**RE: SUPPLEMENTARY FLOOD ASSESSMENT IN RESPONSE TO SHOALHAVEN CITY COUNCIL REQUEST FOR FURTHER INFORMATION – PROPOSED EXPANSION OF SAND EXTRACTION AT PIG ISLAND, TERARA, NSW**

Martens and Associates (**MA**) have prepared this response on behalf of Terara Shoalhaven Sand (the **Proponent**) to address the flood related items in the Request for Further Information (**RFI**) from Shoalhaven City Council (**Council**, dated 19 April 2022, REF: RA21/1000) in relation to a proposed expansion of sand extraction at Pig Island, Terara, NSW (the **Site**).

Map Title / Figure:  
PMF Critical Duration Storm - Proposed Condition  
Water Level Afflux

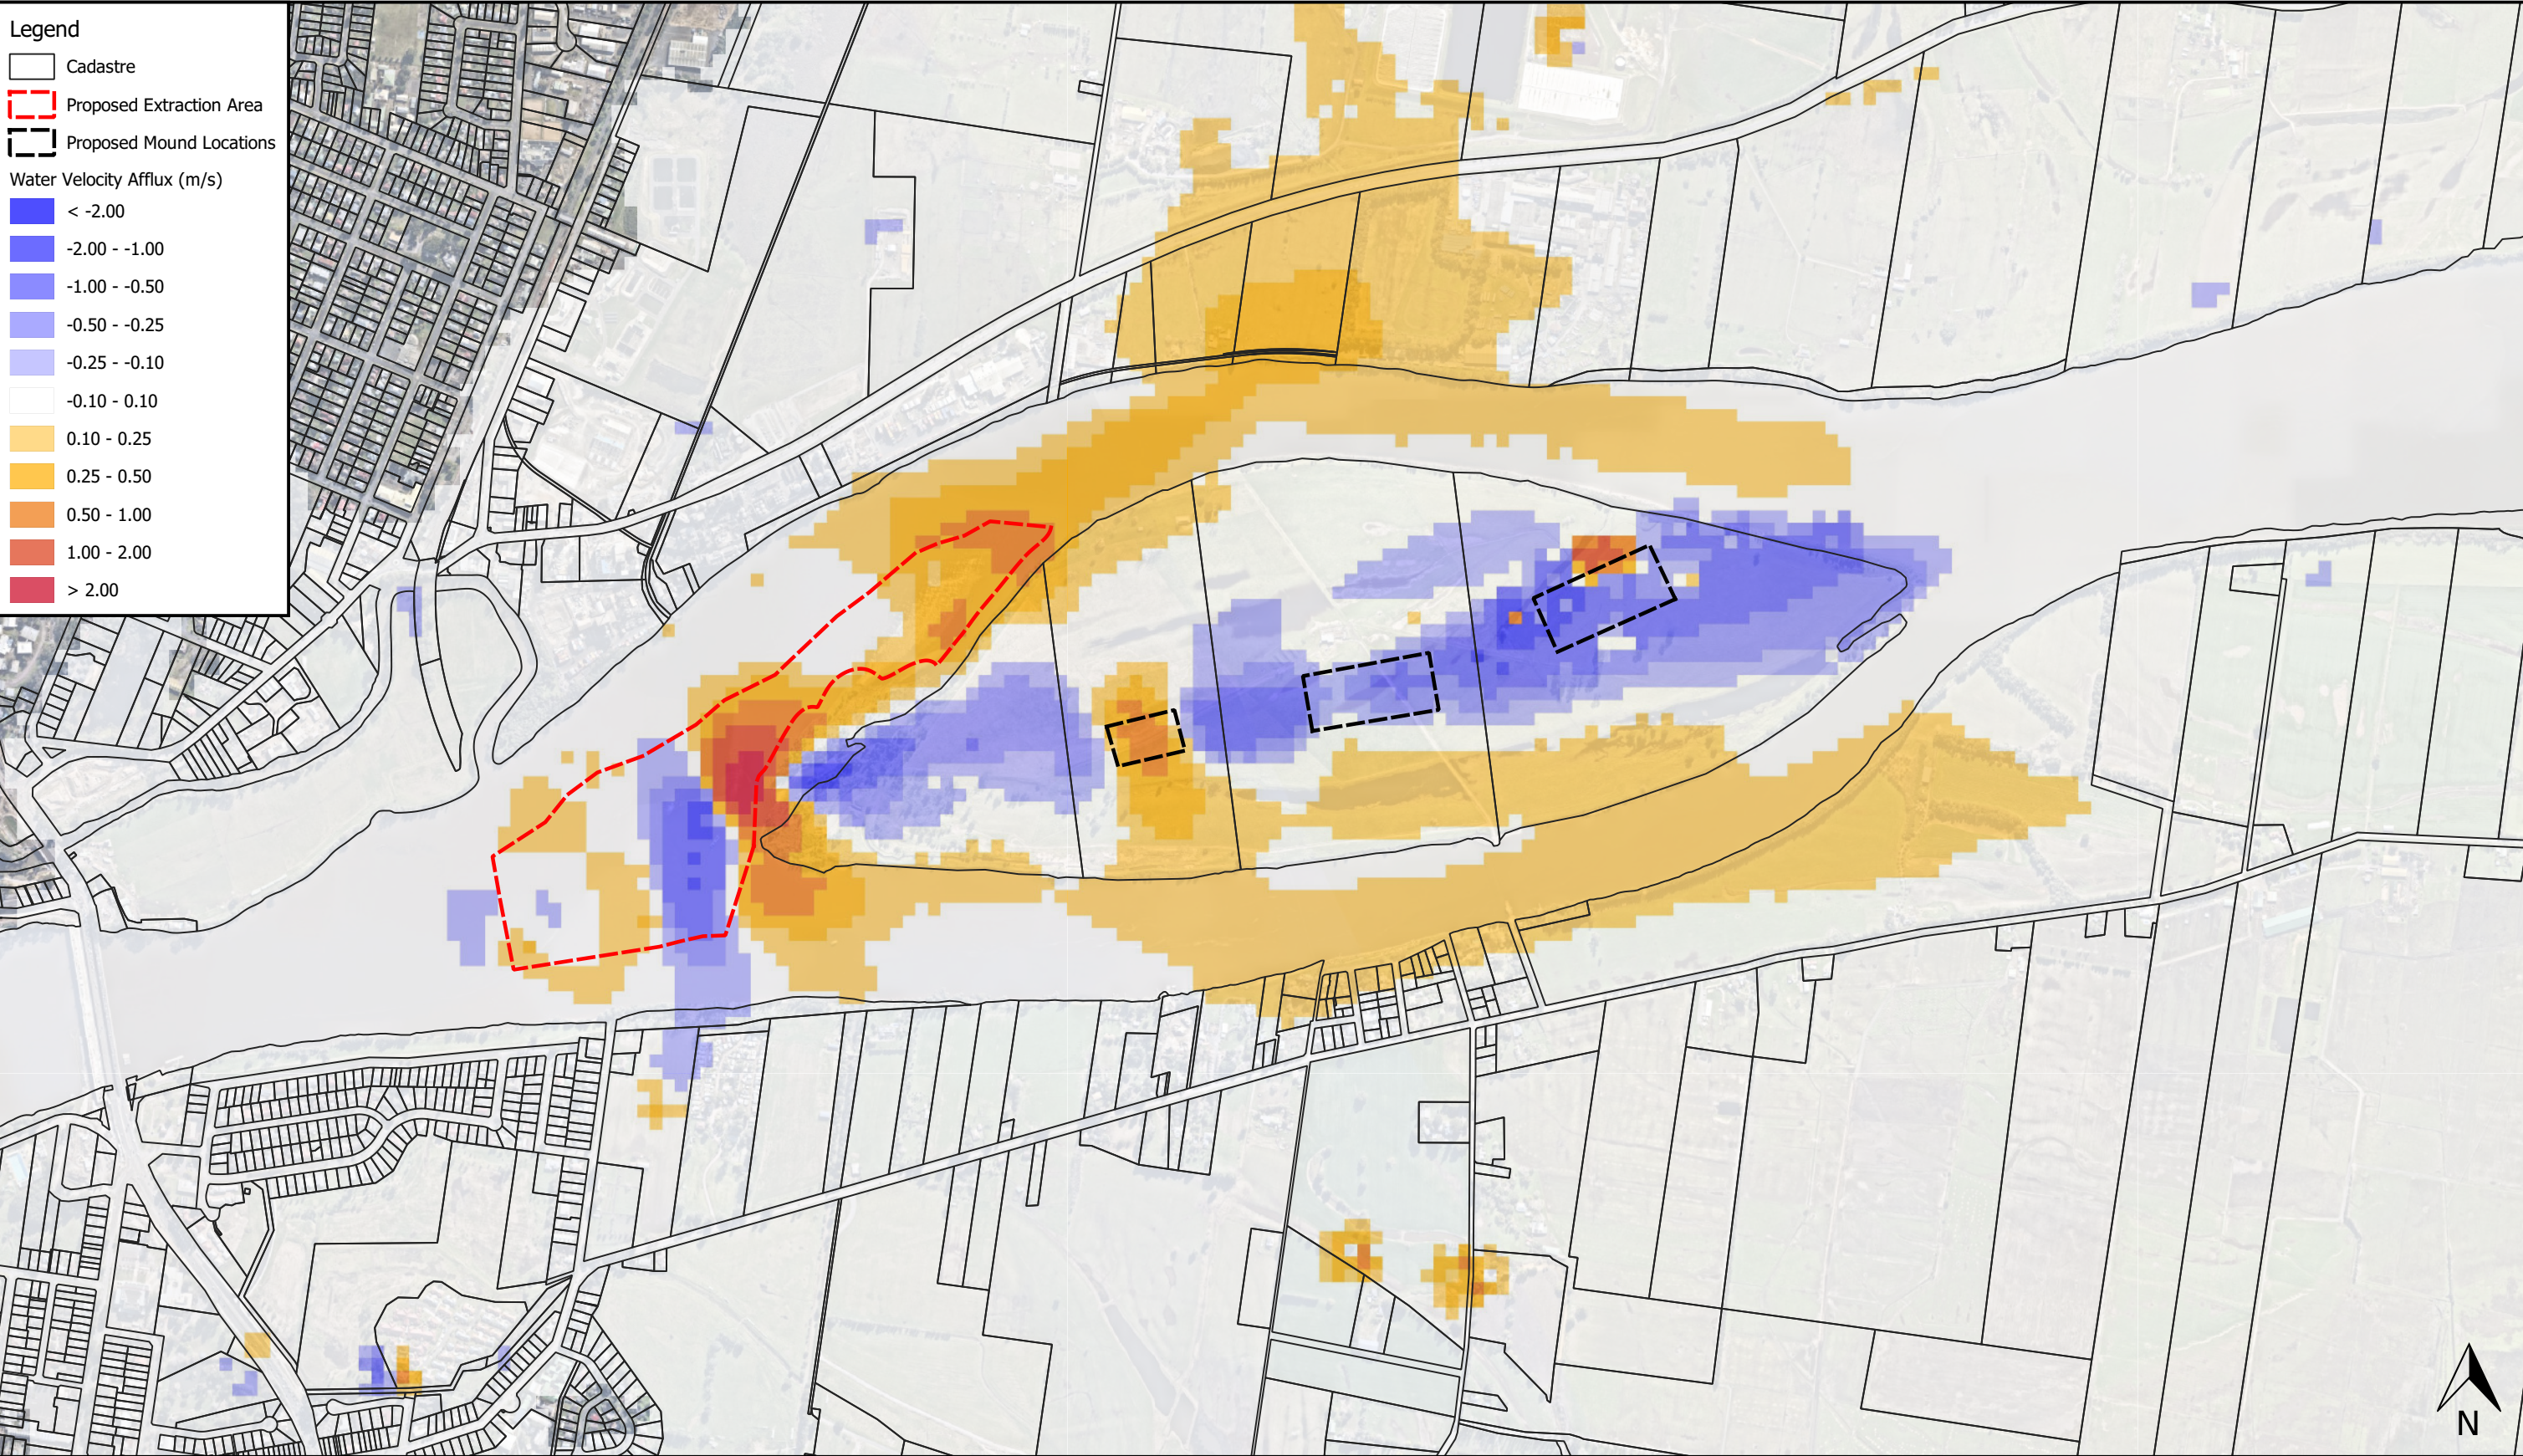
<p>f) <i>A PMF water level afflux map has not been provided and is required.</i></p>	<p>(6) See Attachment A Map FL09 and Map FL10 for the PMF water level and velocity afflux maps respectively.</p>
<p>g) <i>The report identifies that the proposed livestock mounds were designed to be floodfree in a 1% AEP event however the mapping shows these areas also flood-free in a 0.5% AEP event. The design event level of service and any proposed freeboard needs to be clarified.</i></p>	<p>(7) The top of fill mound levels were designed to be just above the 1% AEP flood level with an adopted freeboard of approximately 100 mm. Based on the updated flood model that incorporates the new fill mound locations, the design event for the mounds were linearly interpolated and are as follows:</p> <ul style="list-style-type: none"> <li>- 1 in 168 year ARI for the mound in Lot 2</li> <li>- 1 in 161 year ARI for the mound in Lot 3</li> <li>- 1 in 221 year ARI for the mound in Lot 4</li> </ul> <p>Consistent with the Flood Letter previously submitted, the proposed livestock mounds remain flood free in the 1% AEP event.</p>
